Controller - Programmer w/ Mtg. Hdwr. - Pronto M71/Pronto M71jr

MK6i electronics are only used on Pronto M71 chairs with Rehab seats. Chairs that have Van seats use MK5 electronics. See Pronto M71 parts catalog for parts information.

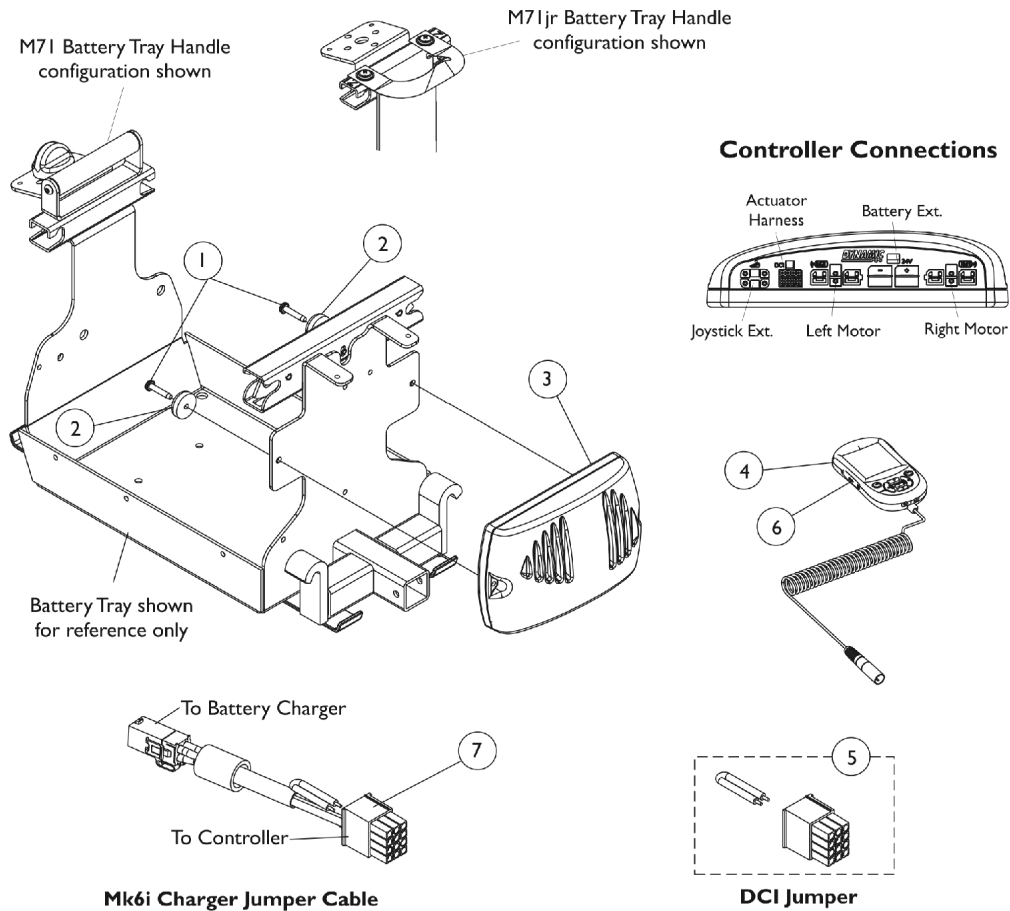
NOTE: A - Not Shown
 B - After 10/8/06 the MK5 NX w/ ACC controller was revised to function as a MK660 w/ ACC or MK5 NX w/ ACC controller. The part # did not change and the label was revised to only show MK660 w/ ACC.
 B1 - Revised controller is backward compatible with MK5 Driver Controls manufactured Before 10/9/06. Controllers in the field that show the MK5 NX w/ ACC label and serial # dated Before 10/9/06 will not have revised software to work with MK6i Driver Controls.
 C - Jumper Cable used on Pronto M71 (ADJASBA) Seating with an ON-Board Battery Charger and Pronto M71jr. (ASBA) models with an ON-Board Battery Charger and NON-Tilt Seating
 D - DCI Jumper is used when an MPJ+ Joystick is used
 E - Part #1148361 controller is no longer required as a replacement for a chair ordered with Manual Tilt Option before 1/19/07.
 E1 - because the software for part #1127270 was revised 8/31/07 to version 2.61a and now accommodates all Manual Tilt optioned chairs shipped before 1/19/07 as well.

F - Used for Chairs with Manual Tilt Option only. Discontinued 8/31/07, see part #1127270 as a direct replacement.
 G - The MK6i Programmer Manual (1141471) is not included and is strongly recommended the guide be ordered or downloaded from Literature Fulfillment.
